Re: Product change notification for Harwin product.

There has been a change to the tape pocket design on the following products:

Old pocket orientation

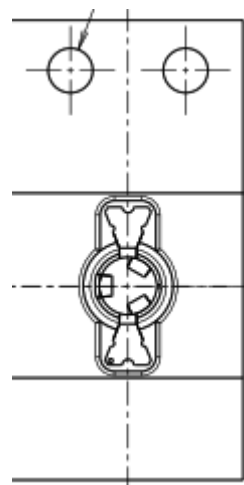
The contacts have changed orientation in the tape:

This revised packaging method has been tested and continues to meet the EIA-481 requirements. The Sycamore Contact sockets are not affected and remain unchanged.

This packaging improvement minimises the risk of these miniature low-profile contacts turning or twisting within the pocket - increasing assembly efficiency.

All new and existing orders at Harwin for S9111-45R product will be supplied in the new tape and reel packaging. Reels with the new orientation pockets will be clearly labelled for a minimum of 12 months. Using the new orientation will require a change to your Pick/Place machine setup.
